Access Compliance Report Public Rights-of-Way (Curb Ramps)

Main Street: HICKORY_BRANCH_RD Cross Street: HICKORY_BRANCH_RD Location: SE

ADA ID: RPAT211008143311 Ramp Type: Type 4 - Parallel Initial Pass/Fail: Fail Overall Compliance: No Severity Score: 2

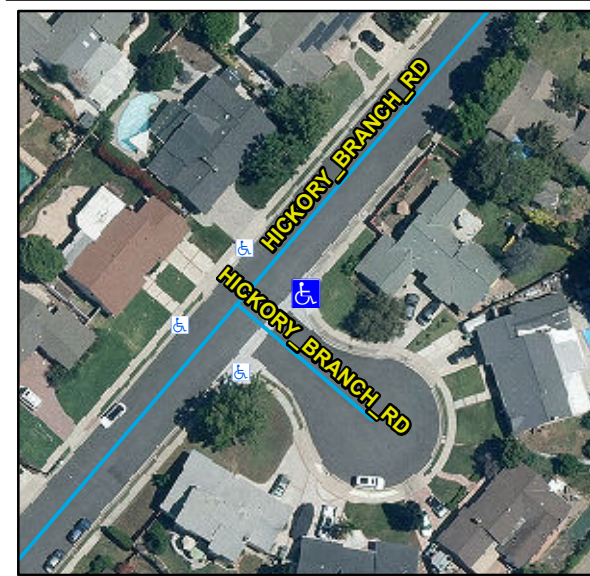
Remove & Replace Curb Ramp With Two New Directional Ramps or Equivalent.

R304.5.3, STD 1115
